## ROCKY FLATS SITE REGULATORY CONTACT RECORD

**Purpose:** Path Forward for Original Landfill (OLF) Seep 7 Drain Extension, Berm Maintenance and Repair, Perimeter Channel Slope Cut and Fill, and Modification of the OLF Monitoring and Maintenance Plan (M&M Plan)

**Contact Record Approval Date:** September 2, 2008

Figure 2. Seep 7 Extension Conceptual Plan

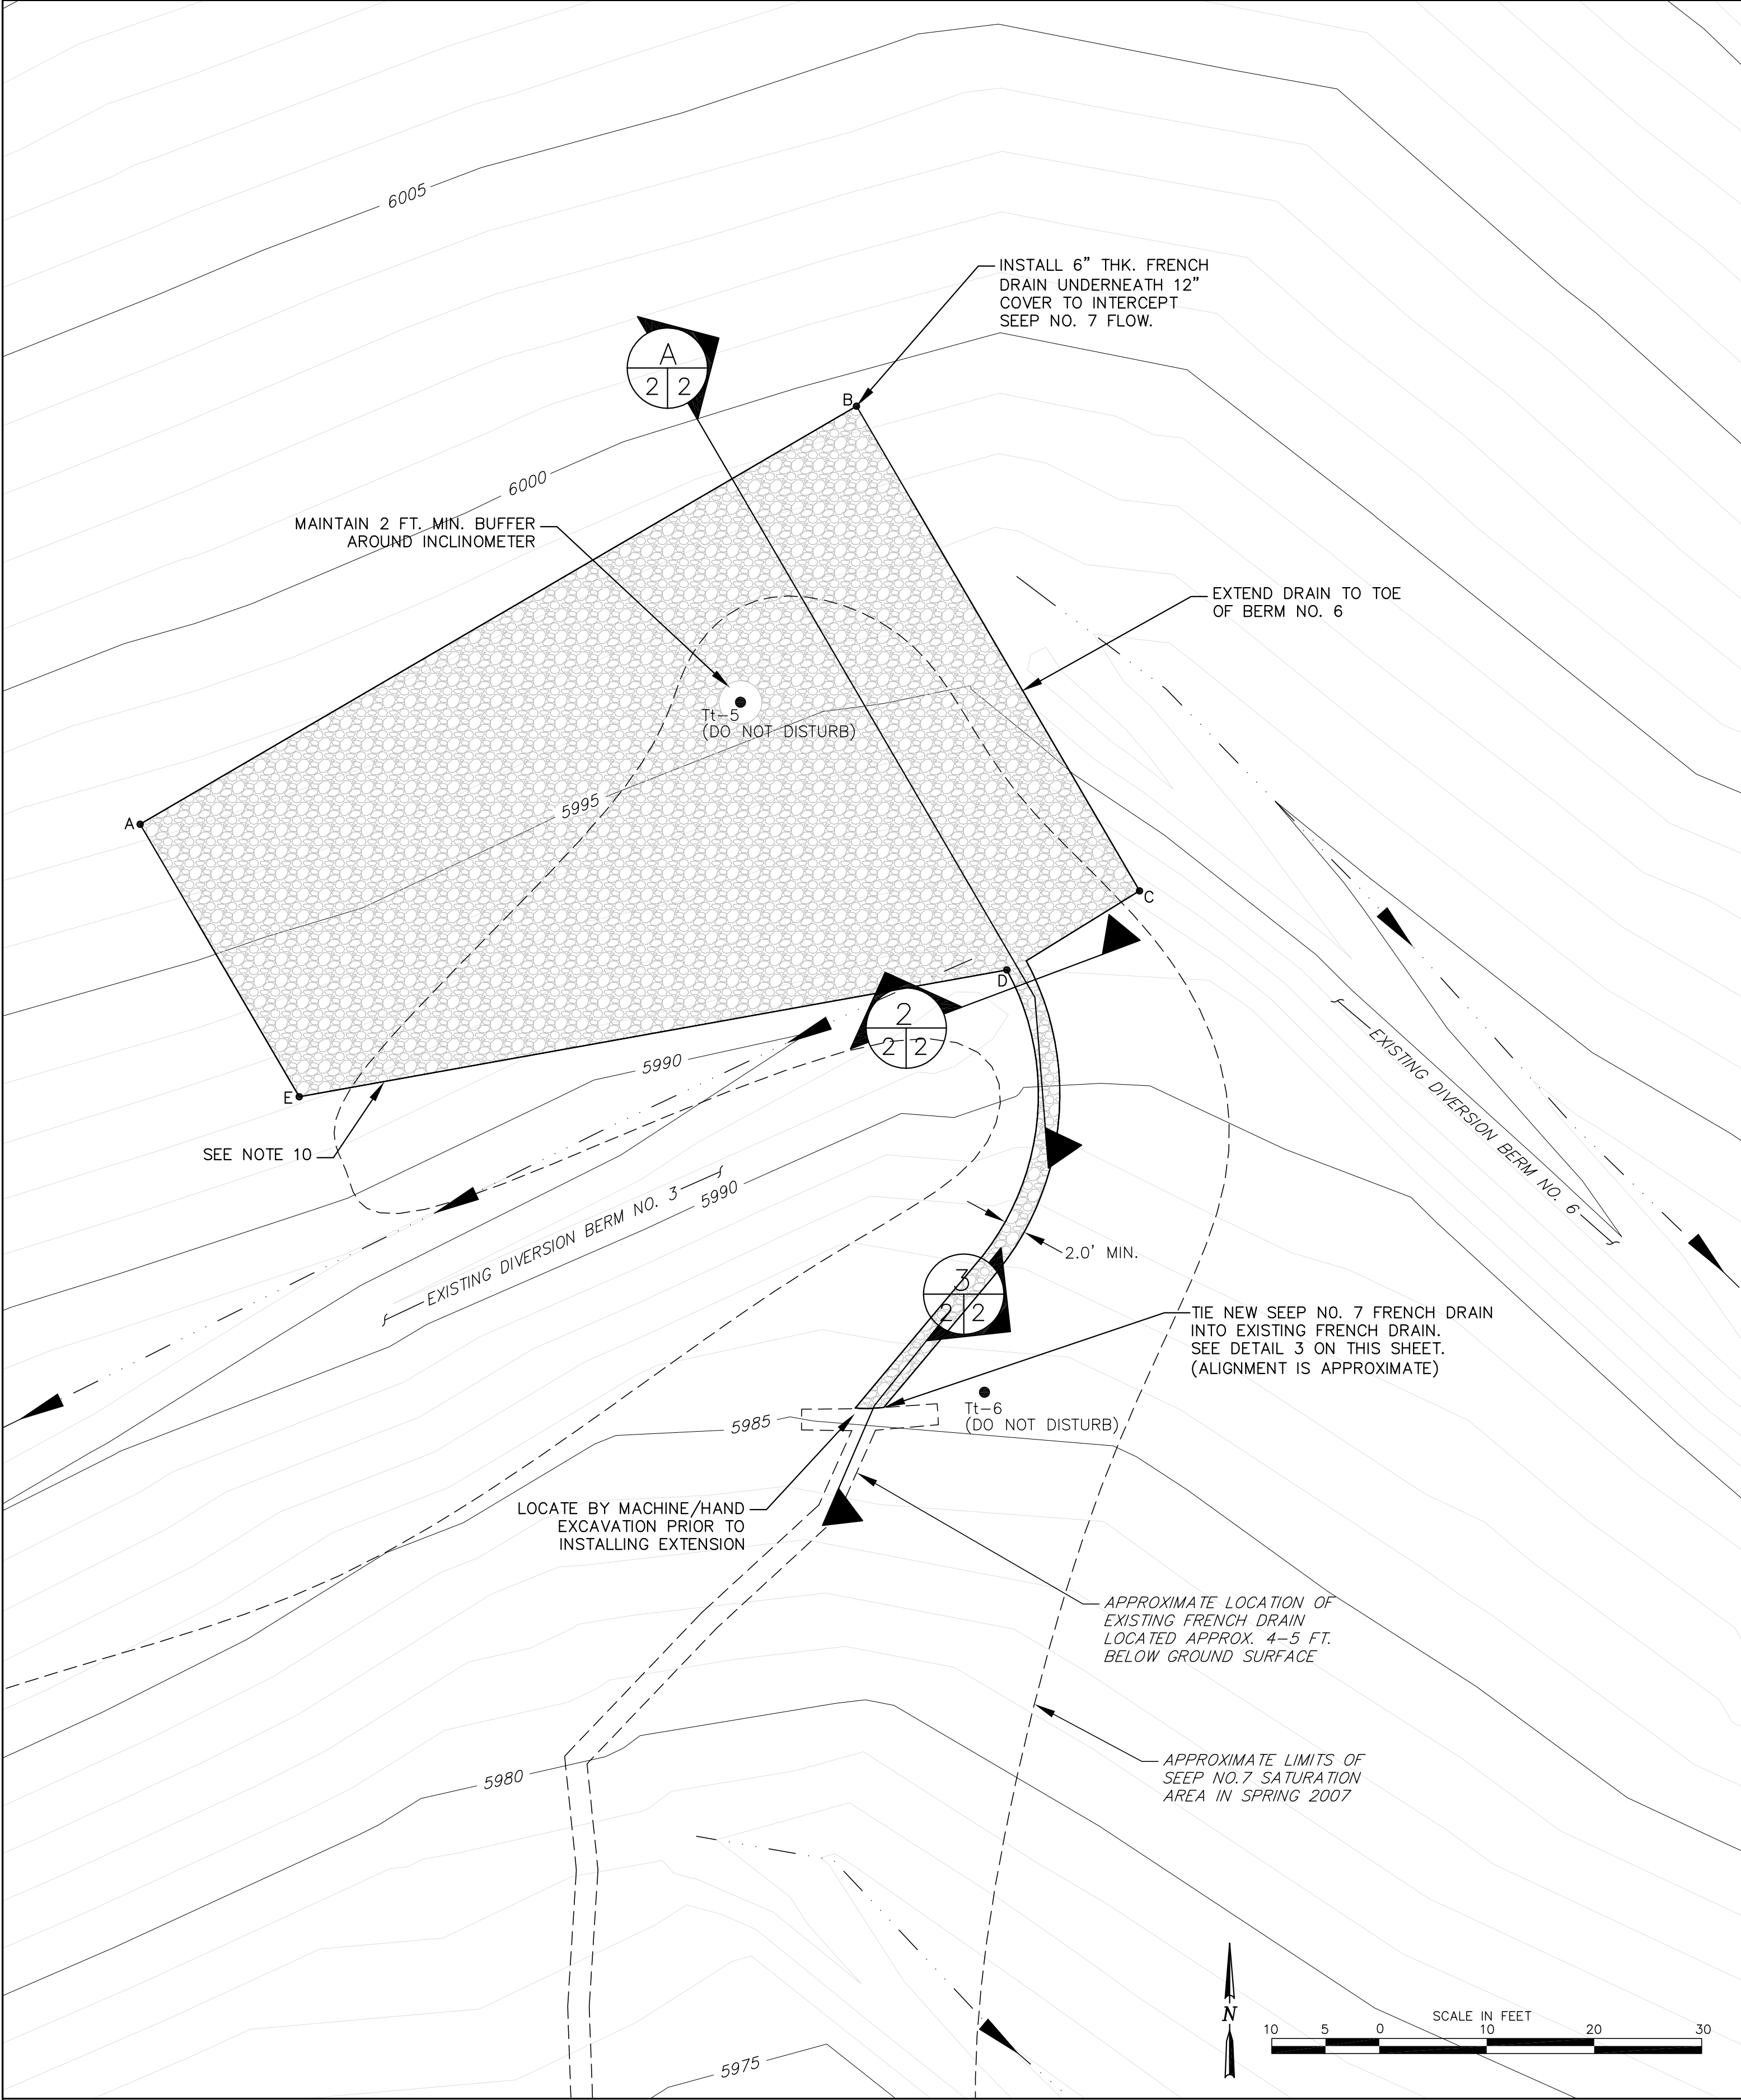
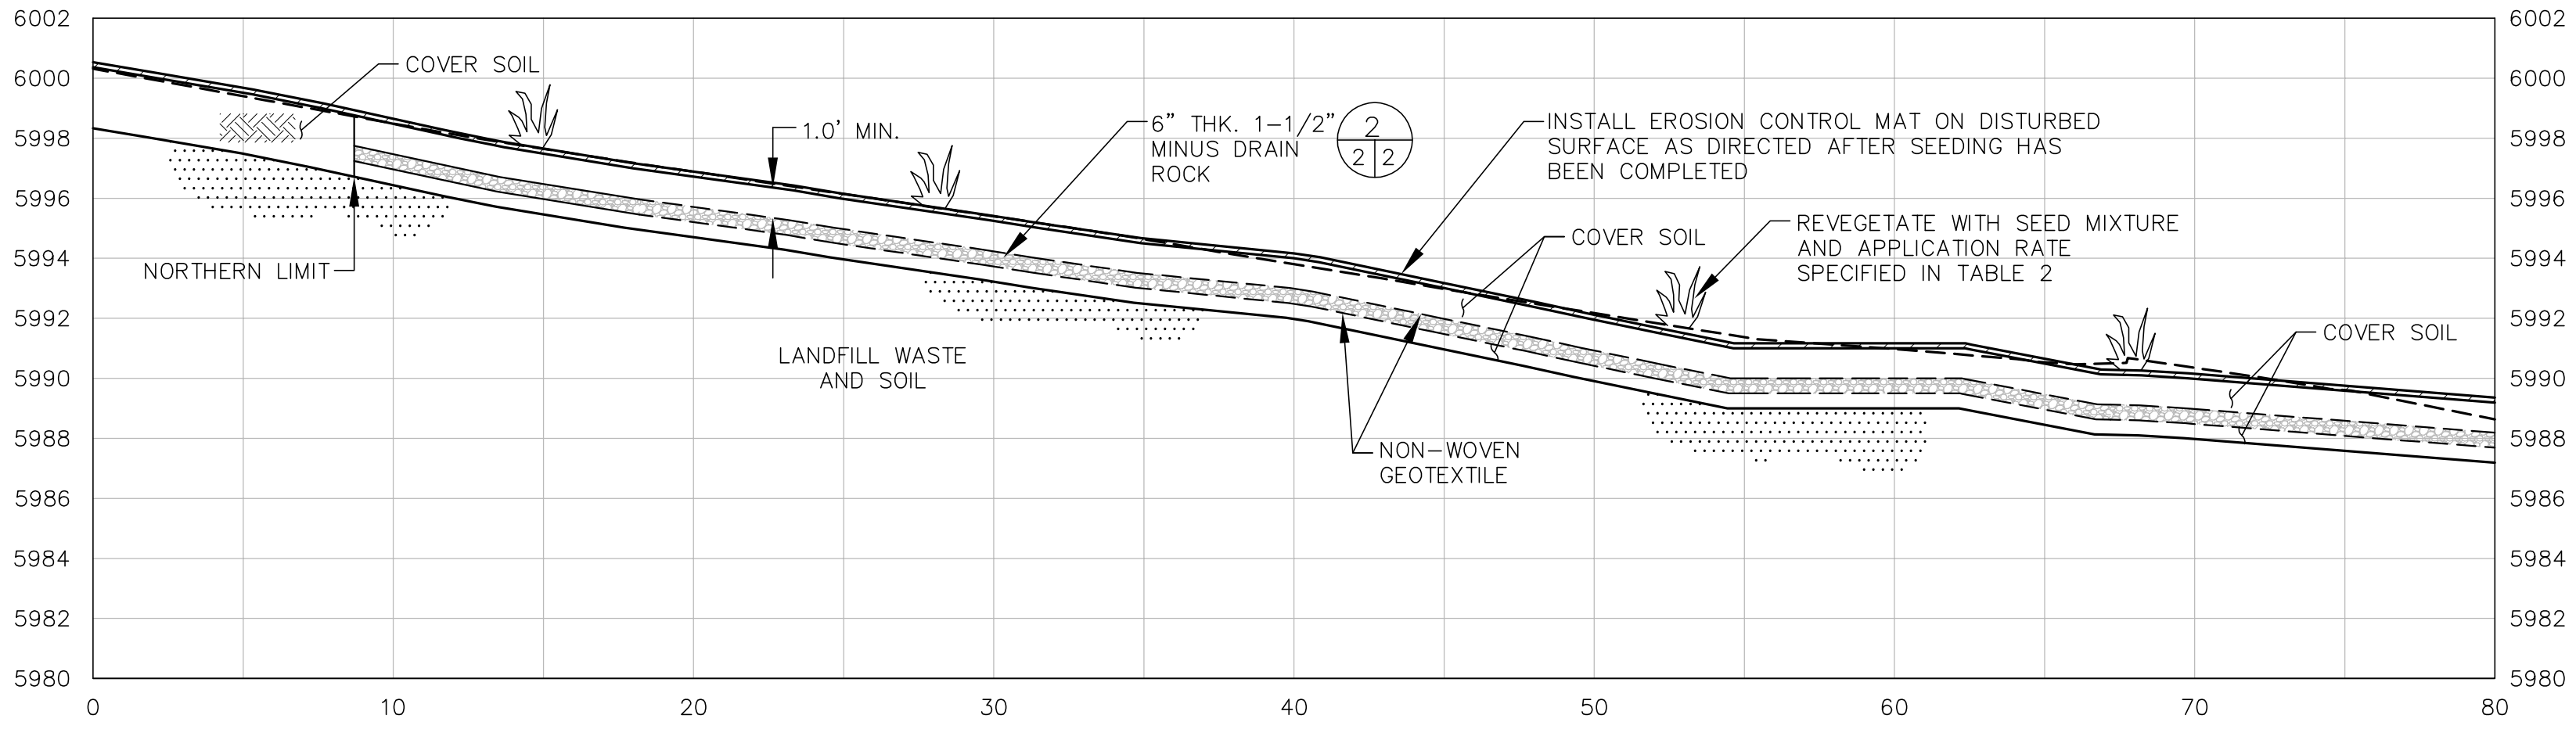
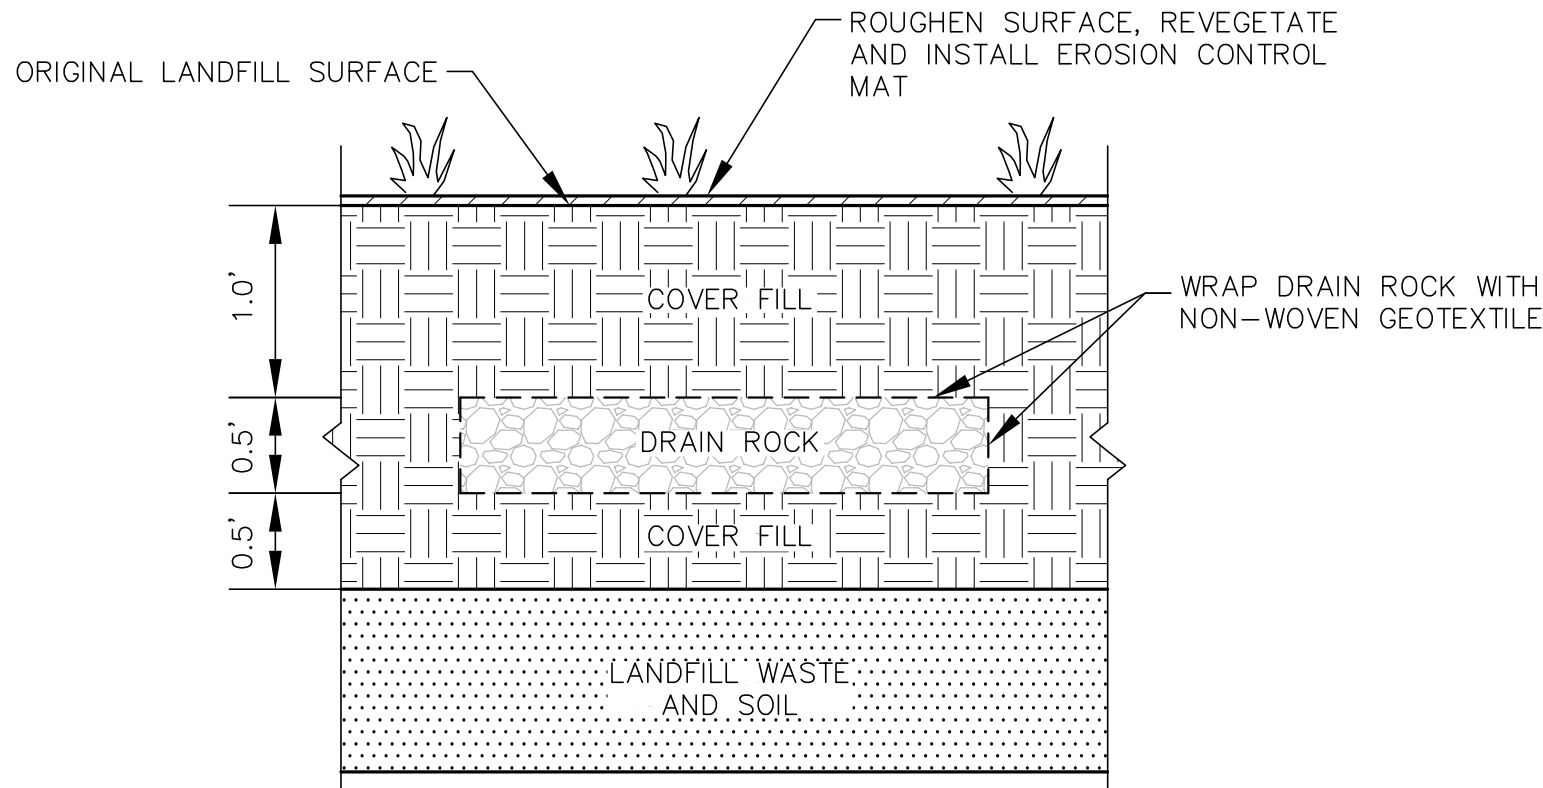
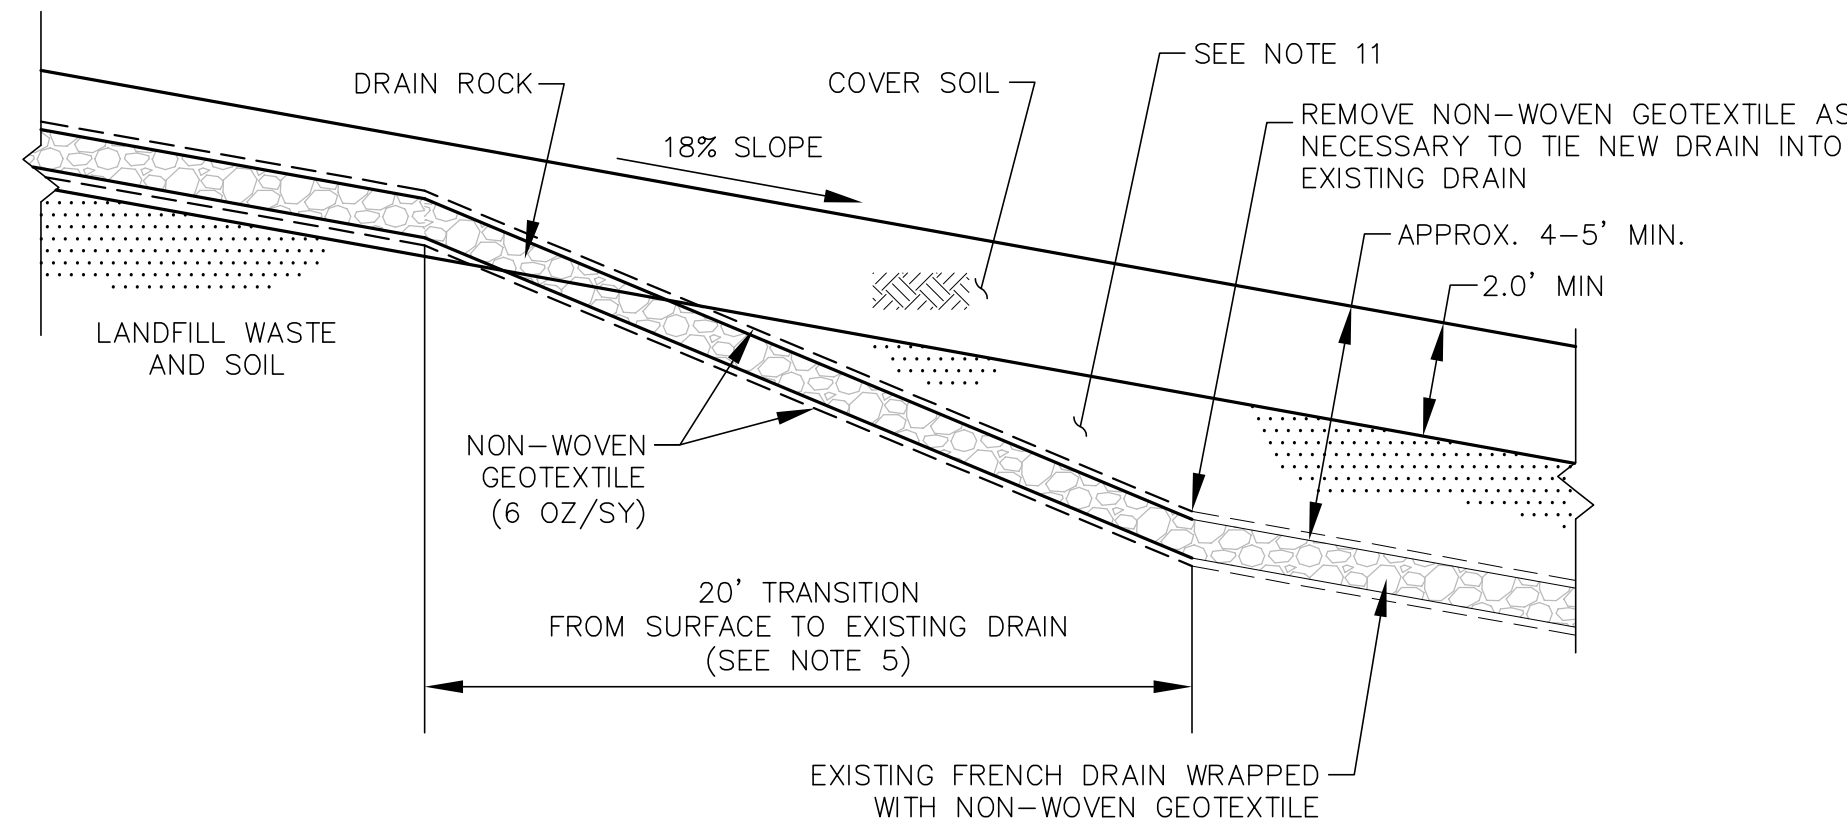
3. Seep 7 drain extension – An extension to the current drain will be installed upgradient within the 2-foot cover depth in the general area where this seep has expressed (“day lighted”) on the surface and resulted in saturation of surface soil. This will be carefully constructed in the cover layer so as not to intrude into the underlying soil/waste. At its southern end, the excavation will extend below the cover material for a short distance to a depth of 4 to 5 feet to tie into the existing drain. Figure 2 shows the conceptual design for the drain extension.

The OLF M&M Plan will be modified to document the drain extension, including updating the drawings to show the location.

**Resolution:** The final design of the Seep 7 drain extension will be submitted to CDPHE for approval. Construction of the Seep 7 drain extension will take place after CDPHE approval.
